STAFF REPORT

SUBJECT: H-2022-0066
Artisan Victory Market – AZ, CUP, PP, PS

LOCATION: 2820, 2910, 2960, 2990 and 3020 S. Eagle Rd., in the SW 1/4 of Section 21, T.3N., R.1E. (Parcel #S1121336051; S1121336101; S1121336176; S1121336200; S1121336230; S1121336251; and S1121336276)

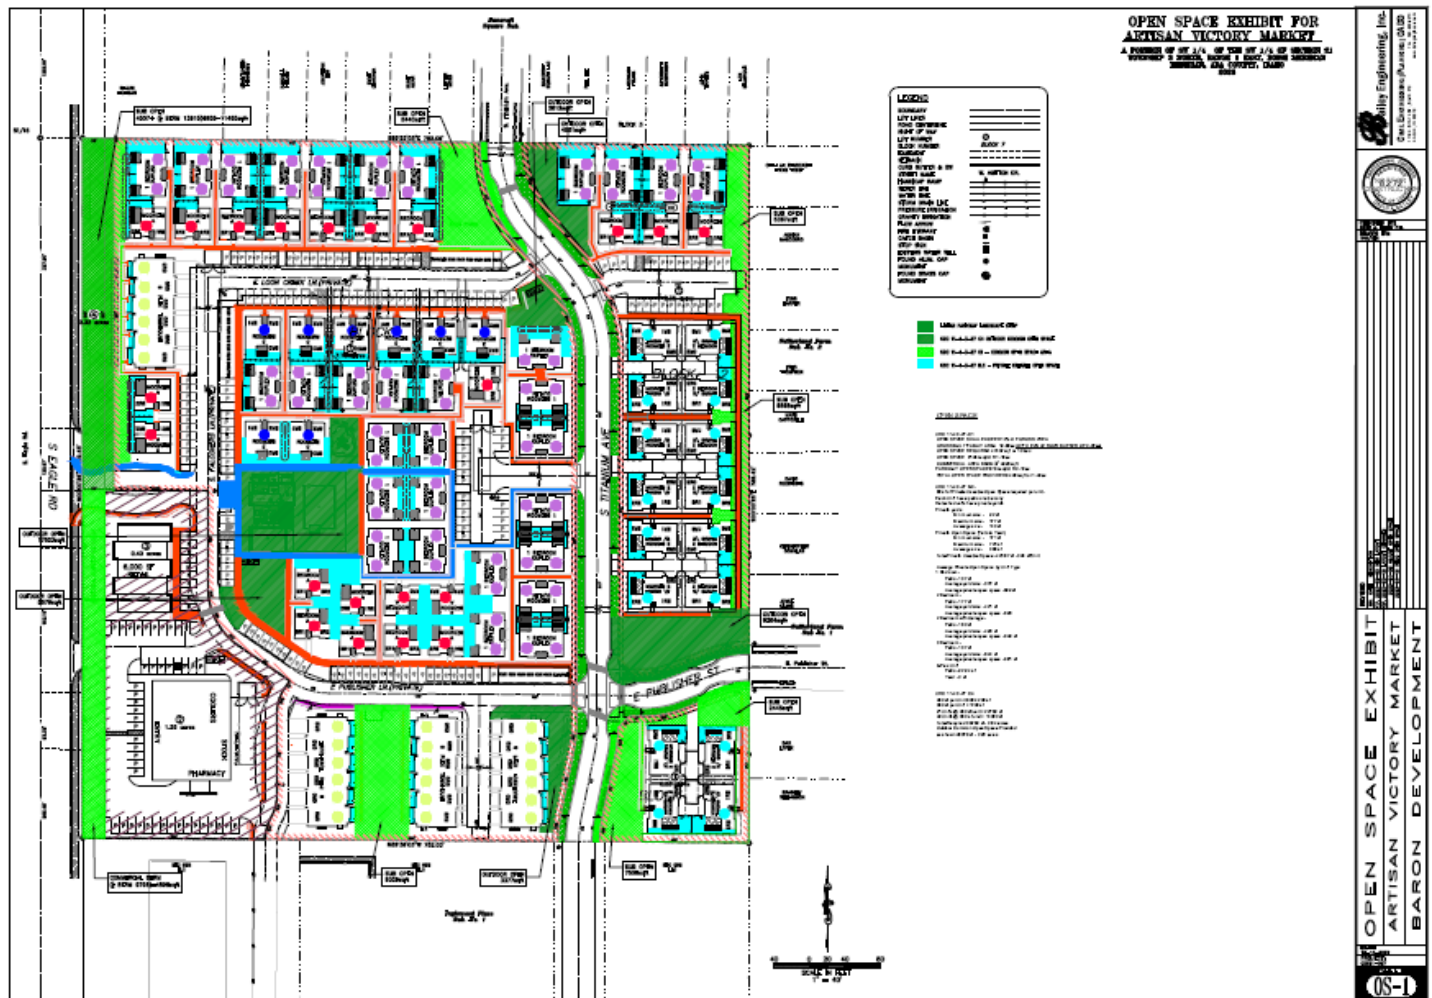
At a minimum, a total of 36,750 s.f. (or 0.84 of an acre) of qualified outdoor common open space is required to be provided per this standard. In order to meet the baseline requirement noted above and this standard, a total of 1.93 acres of qualified open space is required (2.47 acres is provided). The revised open space exhibit submitted ~~with the application~~ after the Commission hearing exceeds the minimum code requirement ~~however, the applicant should remove the linear open space along the south boundary from the calculations as this area doesn't meet the minimum 20 foot dimensional standard noted below.~~

- d. Remove the 15-foot linear open space along the southern property boundary from the qualifying open space calculations. A new open space exhibit is required 15 days prior to City Council to ensure the development still complies with the multi-family common open space standards.

Common open space shall be not less than four hundred (400) square feet in area, and shall have a minimum length and width dimension of twenty feet (20'). *All of the green areas depicted on the revised open space exhibit in Section VII.E meet this requirement.*
